# **Newcastle Ocean Baths**

**Meeting 4 MINUTES**  
**March 2021**

Newcastle Ocean Baths, Preliminary design  
Stage 1 – Pools and promenades

#### 2 'OBSERVATION DECKS'

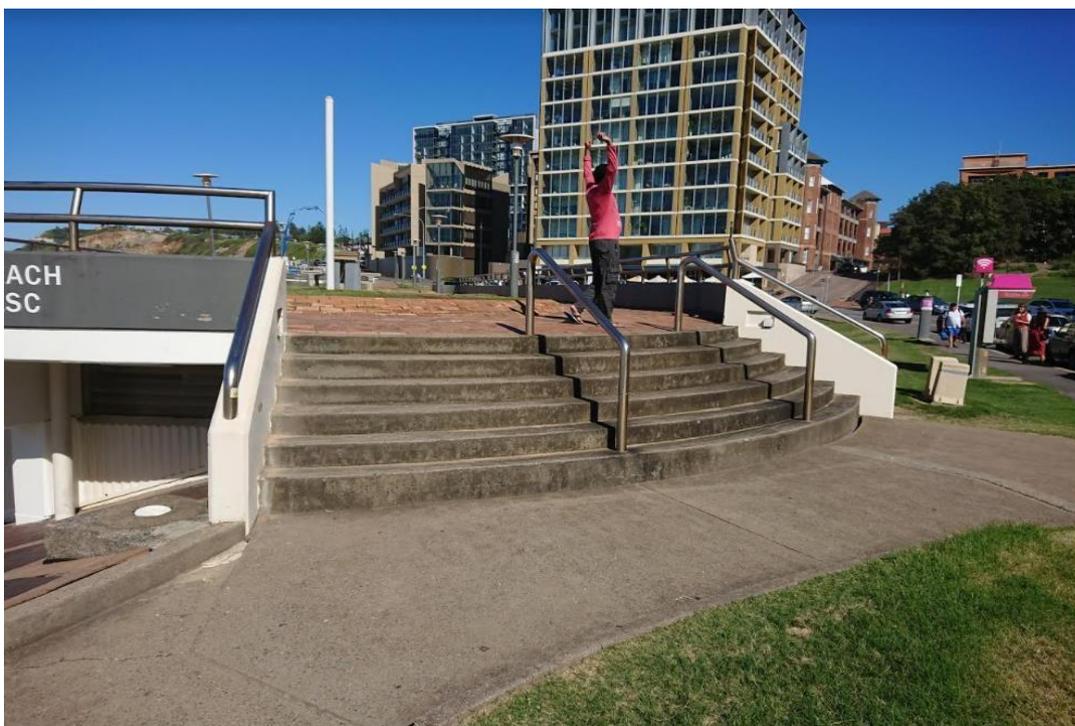
Upper two (of three) tiered platforms with views to Tomaree peninsula. Premier opportunity for picnic tables, seating, whale watching telescope, wedding/surfing photos and interpretation. Additional ambulant access by pedestrians & cyclists off Bathers Way direct to upper and lower concourses reduces congestion at southern ramp and central access.
